TECHNICAL SERVICE BULLETIN / DISTRIBUTOR RECALL NOTICE

NHTSA Recall No.: 26e-041

Subject: Safety Recall – WARN® Wireless Remote Kits for Truck and Utility Winches

Product Identification Information

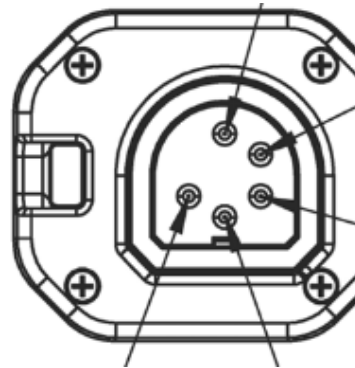
Wireless Receiver produced after week 50 of 2023 (with date code later than 5023):

Date code can be found printed on the module housing representing the week number followed by year in the format “WWYY”:

AND can also be identified by wireless Receivers that possess only 5 connector pins:
